The following text describes changes that need to be made to Annex D of 802.1X-2001 in order to align it with the latest IETF draft on 802.1X and RADIUS guidelines (draft-congdon-radius-8021x-20.txt). This document should be published as an informational RFC soon.

In the following sections, a description of the change is provided as well as instructions on how to update Annex D. New text extracted from the IETF draft is included in a different font (Courier New). This text may need further updates to align it with IEEE editor's conventions and references.

D.4 RC4 EAPOL-Key Frame

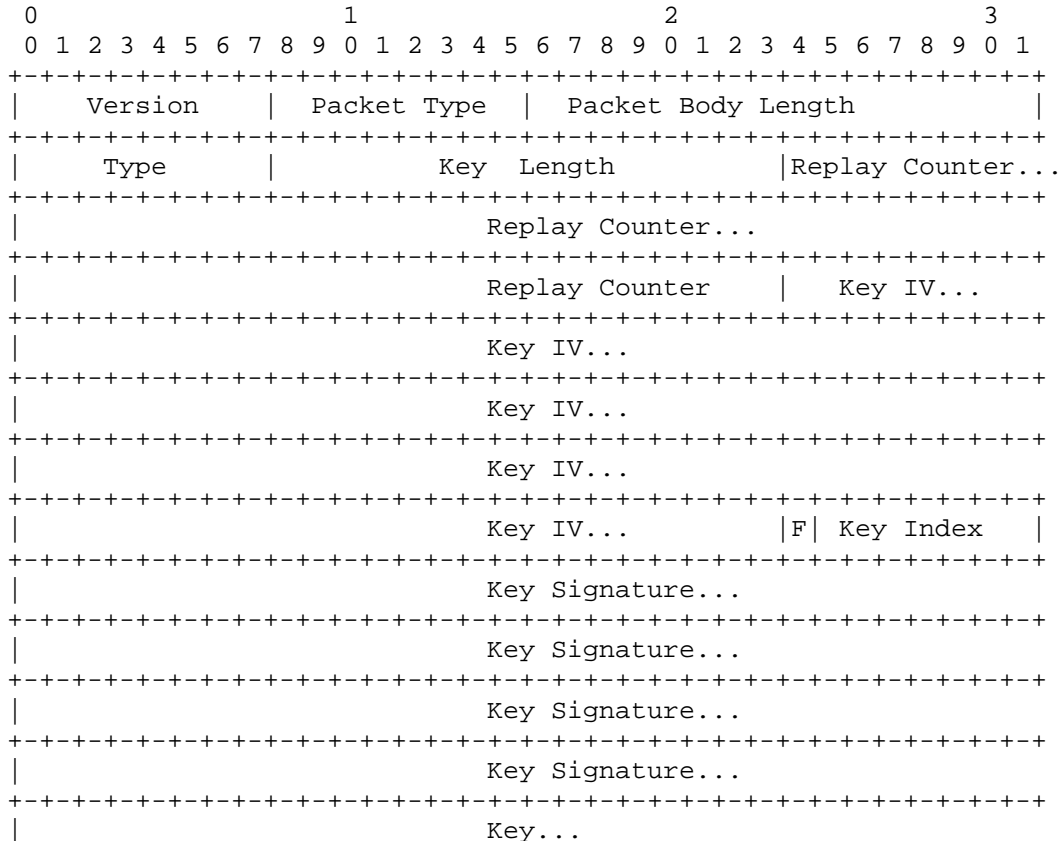
An entire new section has been added to the I-D to better describe the RC4 EAPOL-Key frame and how it is used. Insert this new section into the document and renumber the subsequent sections as necessary:

The RC4 EAPOL-Key frame is created and transmitted by the Authenticator in order to provide media specific key information. For example, within 802.11 the RC4 EAPOL-Key frame can be used to distribute multicast/broadcast ("default") keys, or unicast ("key mapping") keys. The "default" key is the same for all stations within a broadcast domain.

The RC4 EAPOL-Key frame is not acknowledged and therefore the Authenticator does not know whether the Supplicant has received it. If it is lost, then the Supplicant and Authenticator will not have the same keying material, and communication will fail. If this occurs, the problem is typically addressed by re-running the authentication.

The RC4 EAPOL-Key frame is sent from the Authenticator to the Supplicant in order to provision the "default" key, and subsequently in order to refresh the "default" key. It may also be used to refresh the key-mapping key. Note that rekey is typically only required with weak ciphersuites such as WEP, defined in [IEEE80211].
